SUBJECT: Statement of Basis/Proposed Plan for the G-Area Oil Seepage Basin (GOSB) (761-13G) Operable Unit (OU) (U) (SRNS-RP-2018-00460, Revision 1 Redline, October 2018), Revised Public Notice Information, and Savannah River Site's Responses to the Regulatory Comments on the Revision 0 Document, SEMS Number: 93

SRS Responses to South Carolina Department of Health and Environmental Control

Statement of Basis/Proposed Plan for the G-Area Oil Seepage Basin (GOSB) (U)

SRS Responses to EPA Comments on:

Figure 5. GOSB Subunits and Sampling Locations

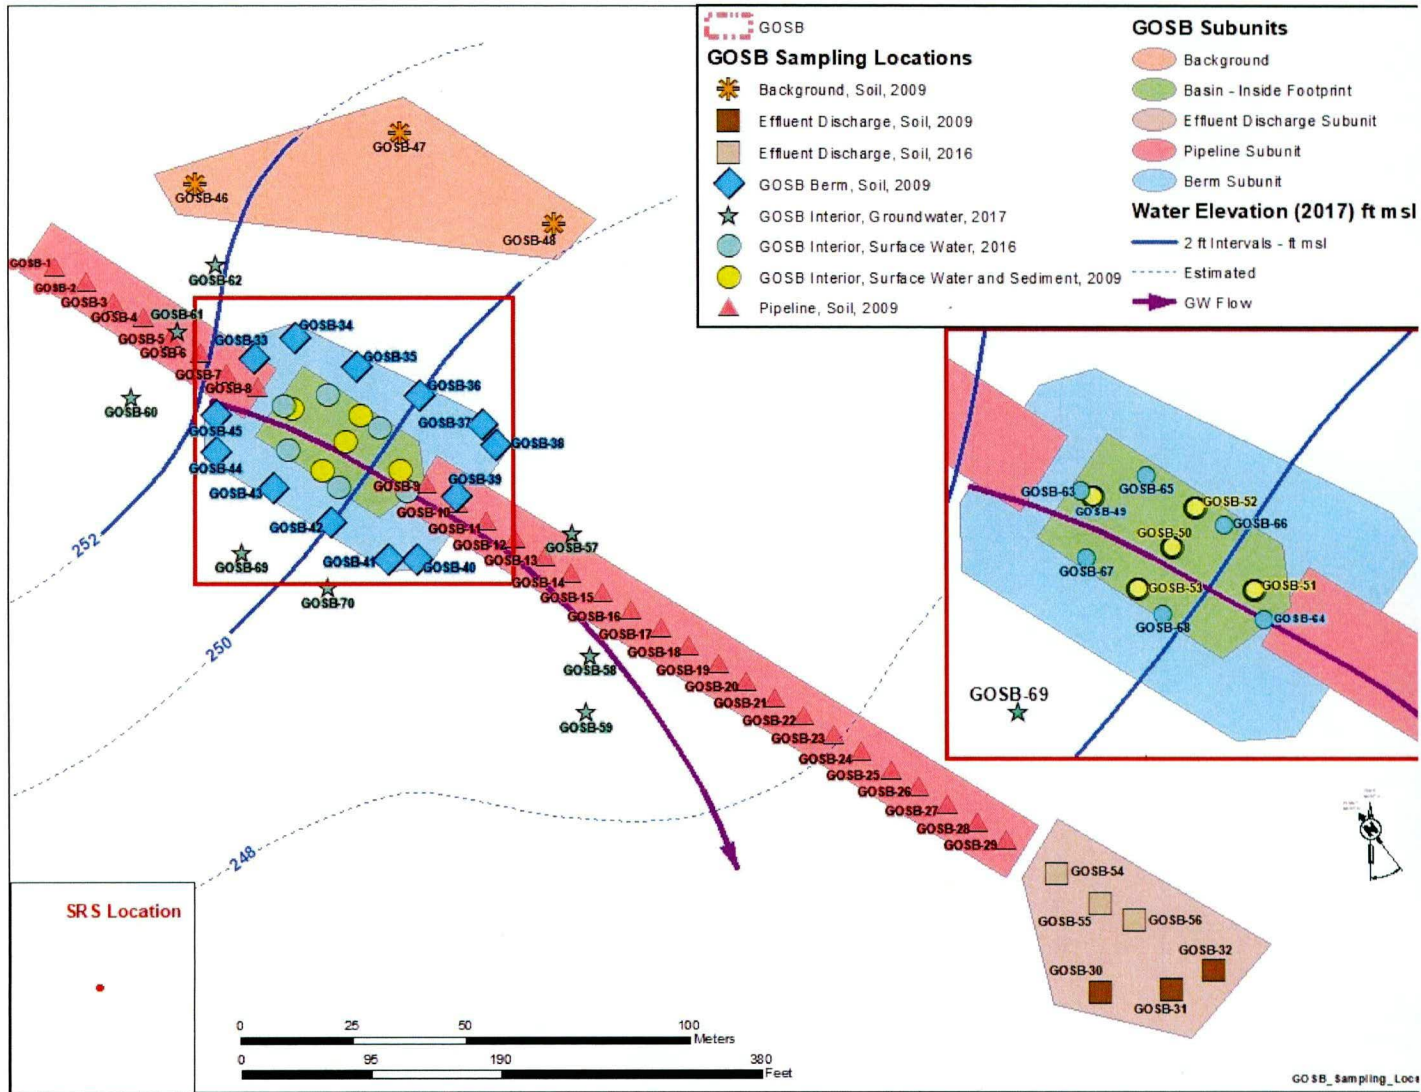
5. Figure 5. The Key lists a symbol for “GOSB Interior, Sediment, 2009” data points but it appears these specific data points were not included on the figure itself.

Response: Agree.

The 2009 sediment and surface water sample locations were collocated and therefore overlap on Figure 5. The Figure 5 key will be revised to show that 2009 sediment and surface water samples are collocated. The revised figure is provided as Attachment 3 to these comment responses.
